Town of Kittery Planning Board Meeting March 24, 2022

ITEM 2—524 US Route 1—Major Site / Subdivision Sketch Plan Review

**Site or Subdivision Sketch Plan
Review**

SKPR-22-4

**OVERALL
SITE
PLAN**

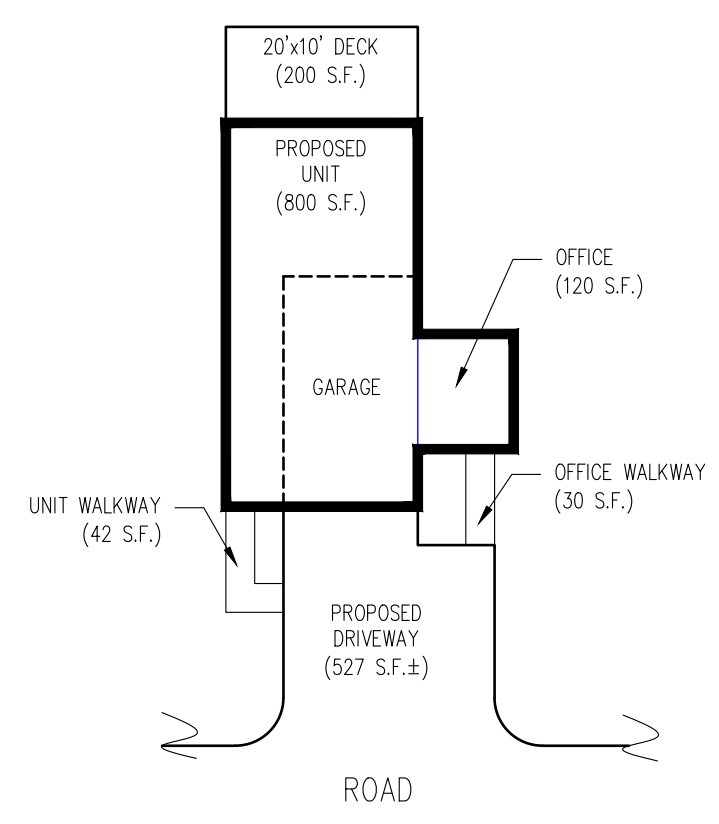
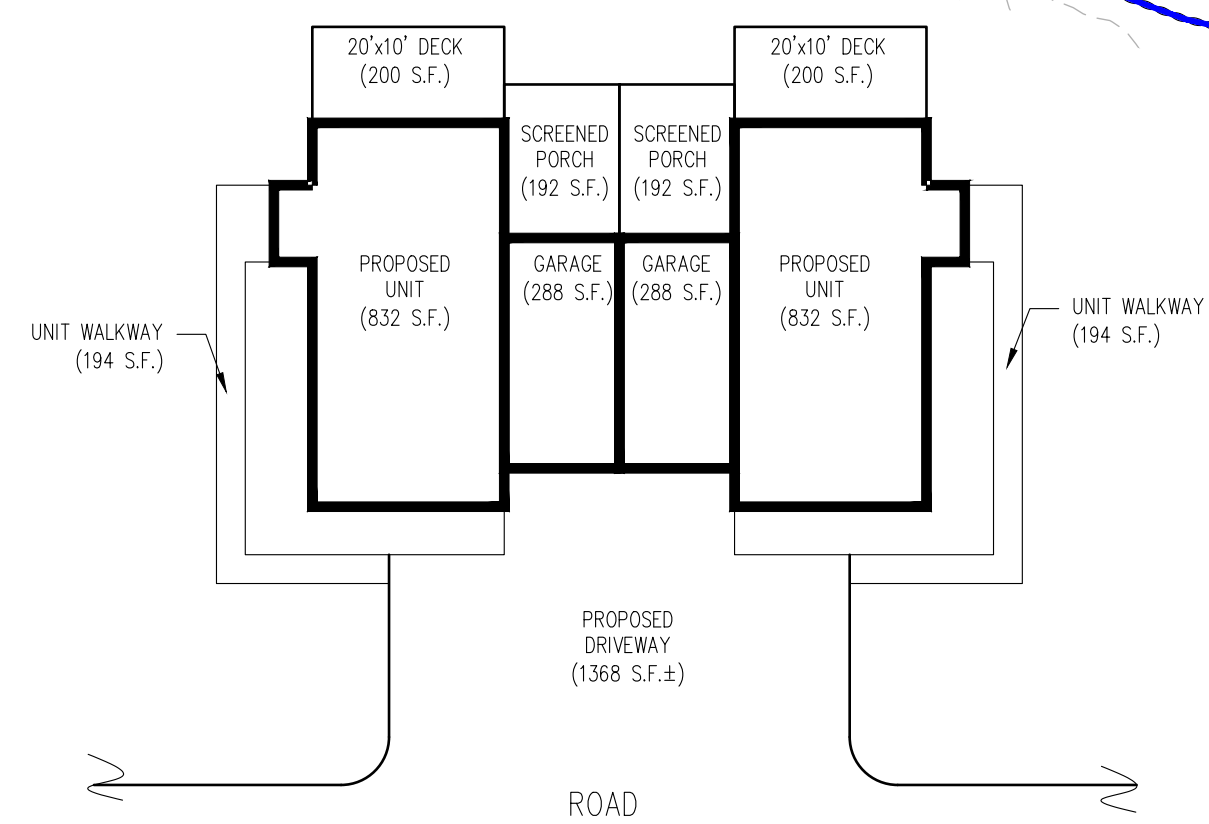
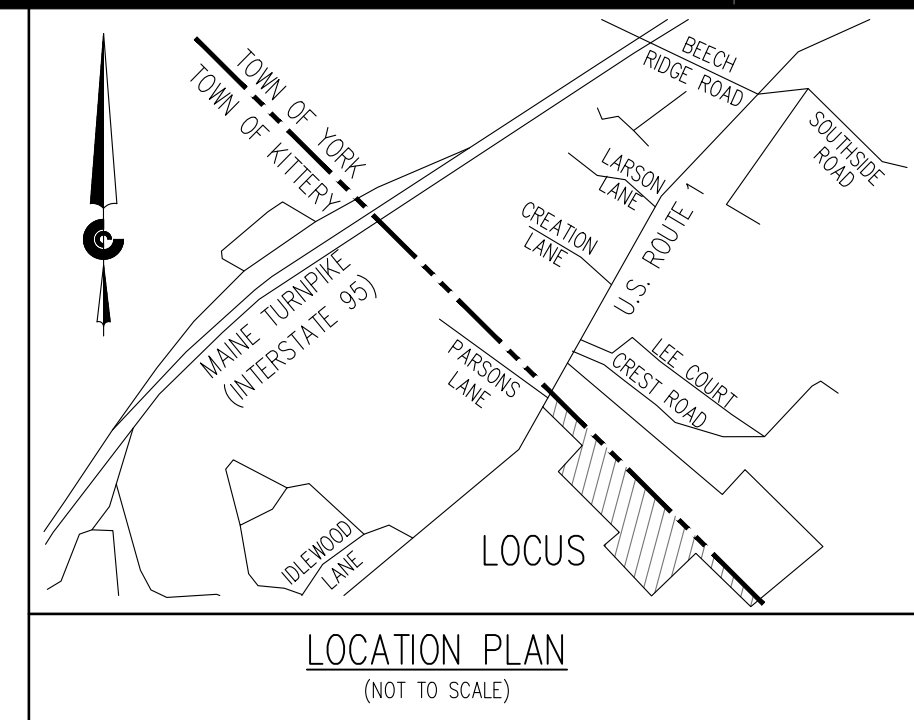
§16.4.23.D(2)(i)	Buffer to neighboring lot with an existing residence within 100 feet of the lot line: 40-ft	It is unclear of the proposed buildings satisfy this condition, as it appears the dwelling units on Landmark Hill (Map 67 – Lot 2) are being encroach upon by the proposed mixed-use dwelling units.

16.4.23.D.Note 2:	For dwelling units that are part of a mixed-use building and are connected to the public sewerage system, one dwelling unit is allowed for each 10,000 square feet of buildable land area. Within the Resource Protection and Shoreland Overlay Zones, one dwelling unit is allowed for each 40,000 square feet of land area within these zones. If the parking for the residential units is encompassed within the building, the minimum required buildable land area per dwelling unit is reduced to 7,500 square feet, except in the Resource Protection and Shoreland Overlay Zones where the area per dwelling unit remains 40,000 square feet.	It is unclear if the proposed mixed-used dwelling units meet the intent of the code, as uncertainty lies around the interaction between the respective dwelling unit and the office space. To wit: is the intent to rent the office space of each dwelling unit or is it designated as personal office space? Also, the land area per dwelling unit calculation is incorrectly provided, as the current plan has a variable of 5,000-sf per dwelling unit where 10,000-sf or 7,500-sf are the standards depending on a building's characteristic. Further, the Board needs to determine if enough parking spaces are provided for the attached offices.

16.4.23.D.Note 3:	For elderly housing dwelling units that are connected to the public sewerage system, one dwelling unit is allowed for each 15,000 square feet of buildable land area. Within the Resource Protection and Shoreland Overlay Zones, one dwelling unit is allowed for each 40,000 square feet of land within these zones. If the parking for the elderly units is encompassed within the building, the minimum required buildable land area per dwelling unit is reduced to 10,000 square feet, except in the Resource Protection and Shoreland Overlay Zones where the area per dwelling unit remains 40,000 square feet.	It appears that the number of age-restricted dwelling units exceeds the permitted amount, as the calculus for the mixed-use dwelling units is incorrect.
§16.4.23.D(4)	Mixed-use requirement. The Mixed-Use Zone is intended for the creation of an area in the Town that has a mix of uses and in which no single type of use predominates. To this end, larger scale projects must incorporate a mix of principal uses into the development. Any new development that creates more than 20,000 square feet of gross floor area must include at least two principal uses as set forth in the list of permitted uses and special exceptions. To fulfill this requirement, the smaller use or combination of smaller uses must contain at least 10% of the gross floor area. The combination of retail uses that are permitted uses and one larger retail use allowed as a special exception does not fulfill this requirement. This provision does not apply to the development of a single lot of record as of April 1, 2004, that has a lot area of less than 200,000 square feet.	This standard appears to be satisfied, however, a revised calculation will need to be provided based on the comments concerning the land area per dwelling unit.

There are a few major elements causing an impasse that need rectifying before the sketch plan can move forward, even from an acceptance standpoint. The Board should decide if the proposed mixed-use dwelling units meets the intent of the code. Moreover, the Board should direct the applicant to revise the land area per dwelling unit calculations as they appear to be incorrect. Also, clarification is needed on what “Storage” involves for the 7,200-sf building considering the use has the potential not to be a permitted use in the Mixed-Use zoning district. Further, it appears that the age-restricted dwelling units are not an integral part of the development, which is required. Staff recommends that the Board not accept the plan and have the applicant return to the Board with a revised plan that resolves the outstanding issues and complies with the applicable ordinances.
